**HEARING STREAM 12C: REZONING REQUESTS (LARGE LOT RESIDENTIAL
ZONES)**

**SUPPLEMENTARY STATEMENT OF EVIDENCE OF NEERAJ PRATAP
(STORMWATER)**

ANDREW CARR (SUBMITTER #158)

5 JULY 2024

Figure 3: Cross Section Through The Southeastern Part of the Site

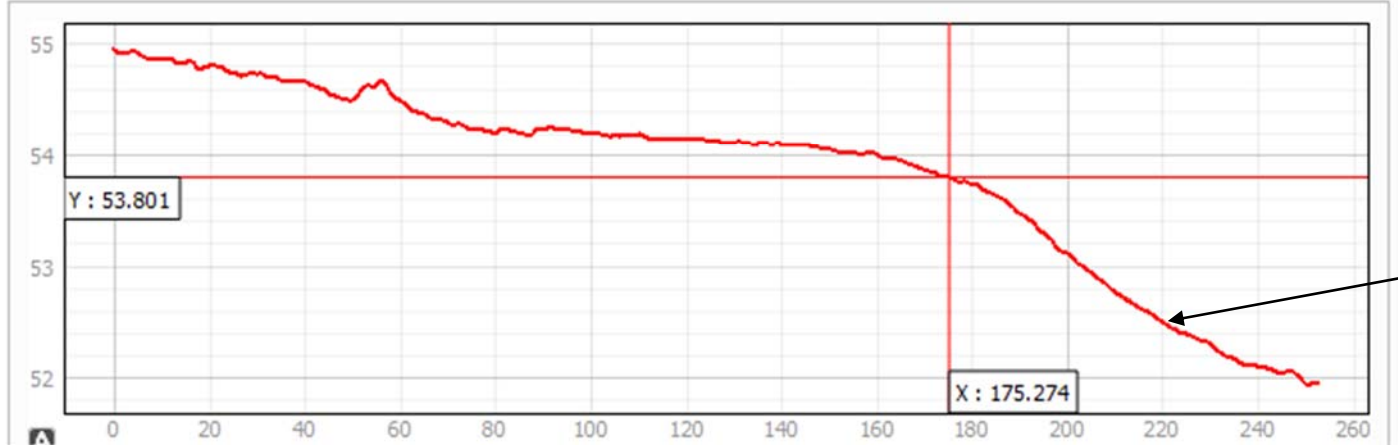
- 2.14 In paragraph 234 of his s 42A report, Mr Buckley highlights that stormwater is required to be managed on-site to be no more than pre-development levels. I agree with his position. However in responding to the Hearing Panel questions on paragraphs 227 and 231, Mr Buckley sets out that it is not clear how the stormwater basins integrate with the OLFPs, and stormwater infrastructure downstream of the site.

- 2.15 Figure 3 shows a cross-section through the southeastern part of the site. As shown by the elevations, the site has a natural fall from west to east. Consequently, I consider that the site contours can be engineered during the subdivision design to convey flows to the proposed southeastern detention basin location.
